Economic Commission for Europe**Inland Transport Committee****World Forum for Harmonization of Vehicle Regulations****Working Party on Brakes and Running Gear****Eighty-third session**

Geneva, 23-27 January 2017

Regulation No. 55**Proposal for amendments to Regulation No. 55 (Mechanical couplings)****Submitted by the Chair of the informal group on Regulation No. 55***

Figure 1
Dimensions of the centre axle trailer

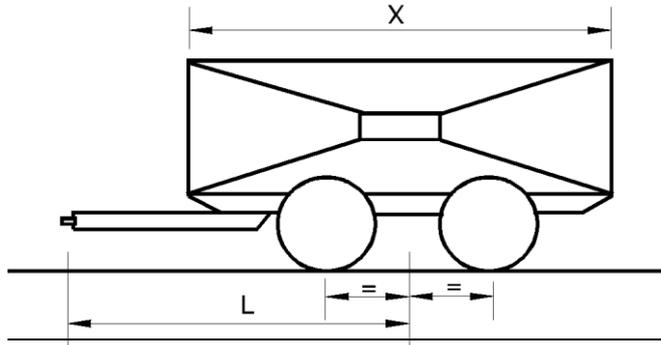
"2.11.4. ~~The V value is the theoretical reference value of the amplitude of the vertical force imposed on the coupling by the centre axle trailer of technically permissible maximum mass greater than 3.5 tonnes. The V value is used as the basis for vertical forces in the dynamic tests.~~

~~X~~ — is the length of the loading area of the trailer, in metres (see Figure 1)

~~L~~ — is the distance from the centre of the drawbar eye to the centre of the axle assembly, in metres (see Figure 1)

~~Note: $\frac{X^2}{L^2} \geq 1.0$ (If less than 1.0, the value of 1.0 shall be used)~~

The V value is a characteristic performance value of the amplitude of the vertical force imposed on the coupling by a center axle trailer. This performance value shall be verified as described in Annex 6 of this Regulation."

Figure 27
Dimensions of the center axle trailer

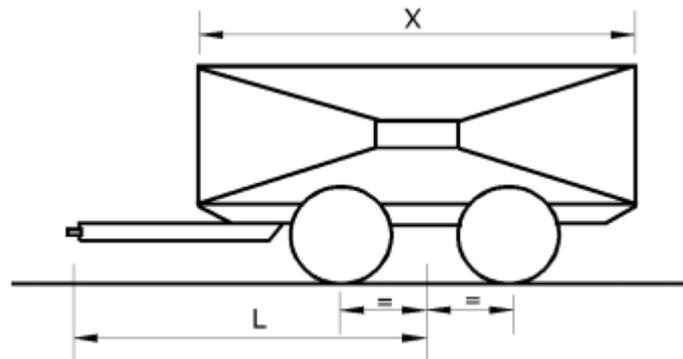
The vertical force imposed on the coupling by the center axle trailer of technically permissible maximum mass greater than 3.5 tonnes is:

X is the length of the loading area of the trailer, in meters (see Figure 27)

L is the distance from the center of the drawbar eye to the center of the axle assembly, in meters (see Figure 27)

Note: $\frac{x^2}{L^2} \geq 1.0$ (If less than 1.0, the value of 1.0 shall be used)

Figure 28

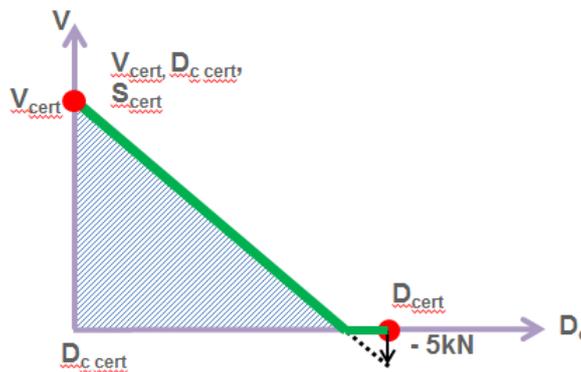
For each combination of certified performance values a diagram as shown in the Figure 28 may be drawn. Calculated performance value requirements D_{C-req} and V_{req} that would fall in the hatched area of the diagram are allowed to be operated in road traffic.

S_{req} shall always be below or equal to 1000 kg.

4.2. If the calculated performance value requirements fall within the hatched area of figure 28, the towable mass is verified with a limiting V-value. For the combination concerned the limiting V-value overrules the certified V-value of the coupling equipment installed.

4.2.1. The limiting V-value is given by a point on the sloping line in figure 28. This point corresponds to the Dc-value requirement calculated for the towable mass."
